Re: TEDS Exception #DE 11-04 KI Subdivision for Access to lower order street (3.2.2), Corner Clearance (4.1.3), Spacing (4.1.1).

### **DESIGN EXCEPTION #DE 11-04**

KI Subdivision

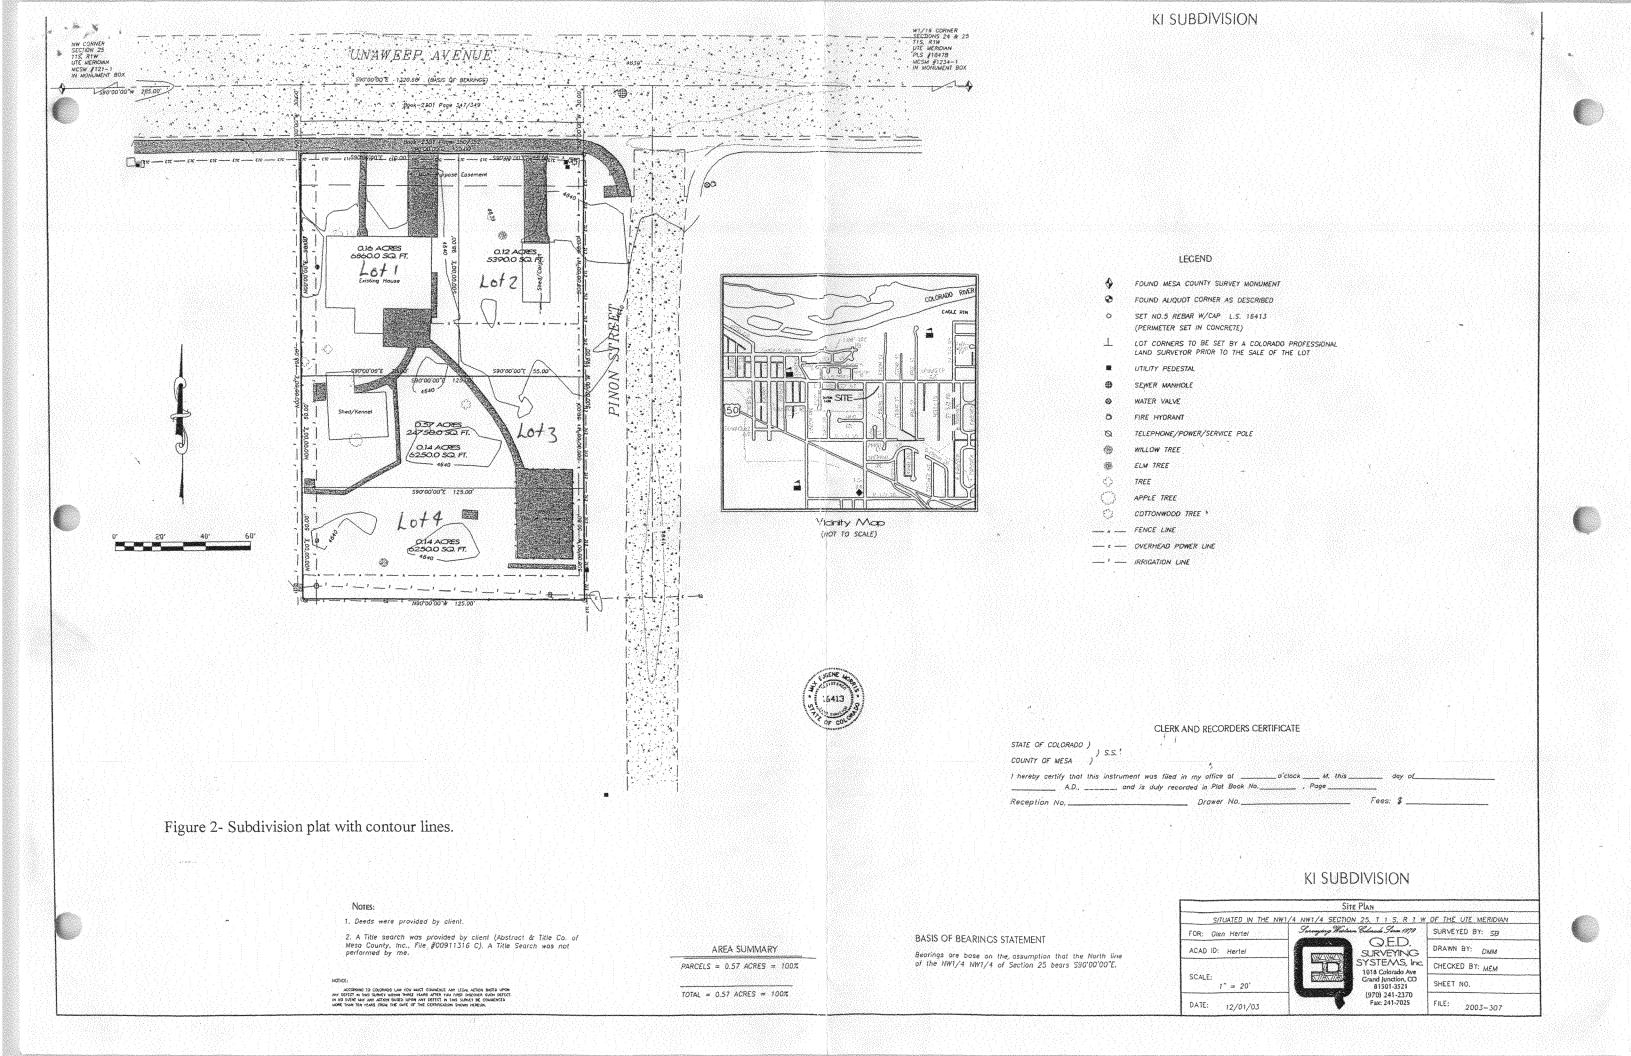
Current traffic counts on Unaweep Ave. indicate 7663 vpd when school is in session. The current driveway configuration would require backing into the right-of-way. There are many existing single family driveways accessing Unaweep in this area. The subdivision could provide an opportunity to eliminate two existing driveways and increase safety in the area.

Staff has suggested a reconfiguration of the subdivision which includes a shared driveway accessing lots 1,2 &3 which can meets TEDS (see attachment Alternate Layout).

Staff believes that other options should be explored and considered to creating safe access for all parcels in accordance with the standards in TEDS and recommends denial at this time.

Staff has analyzed the site and has found that a shared driveway accessing lots 1, 2 and 3 at the minimum width is possible. The shared drive could also accommodate all four lots by further reconfiguring lot lines. The applicant could also chose to eliminate Lot 2, which has a limited building area. (See attached).

Staff believes other options should be explored and considered to creating safe access for all parcels in accordance with the standards in TEDS. Staff recommends denial.
